Eddy County, NM (NAD 83 NME) Banjo 32 Fed Com #731H

# PECOS DISTRICT DRILLING CONDITIONS OF APPROVAL

<b>OPERATOR'S NAME:</b>	EOG
LEASE NO.:	NMNM102034
LOCATION:	Section 32, T.25 S., R.30 E., NMPM
COUNTY:	Eddy County, New Mexico

WELL NAME & NO.:	Banjo 32 Fed Com 731H
SURFACE HOLE FOOTAGE:	395'/S & 1079'/W
<b>BOTTOM HOLE FOOTAGE</b>	230'/S & 1650'/W

Proposed Wellbore Design A KB: 3,187' GL: 3,162'

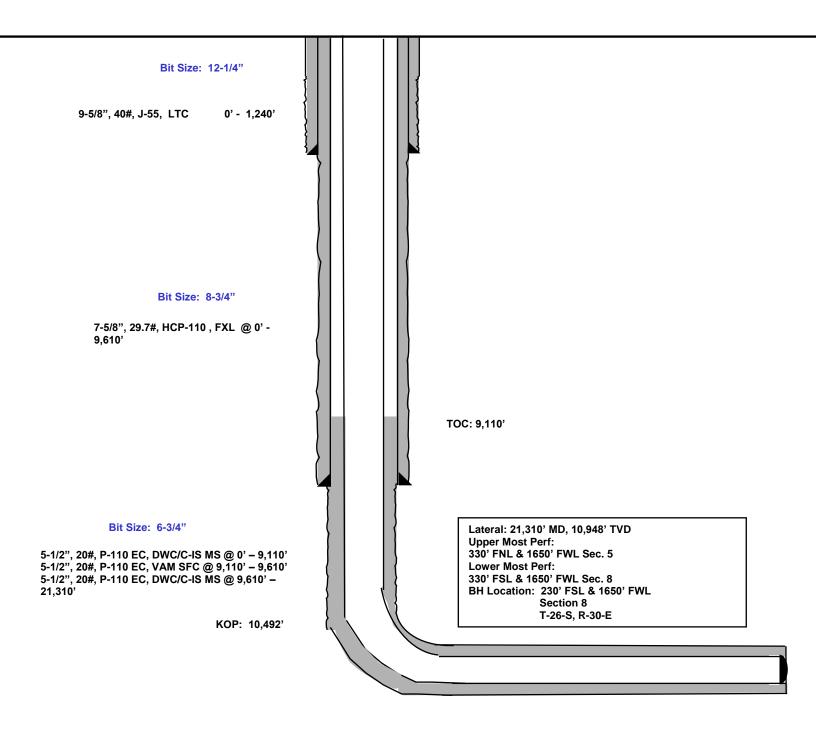
# Operator has proposed to pump down 7-5/8" X 9-5/8" annulus. <u>Operator must run</u> a CBL from TD of the 7-5/8" casing to surface. Submit results to BLM.

- 3. The minimum required fill of cement behind the 5-1/2 inch production casing is:
  - Cement should tie-back at least **500 feet** into previous casing string. Operator shall provide method of verification. **Excess calculates to 21%. Additional cement maybe requried.**
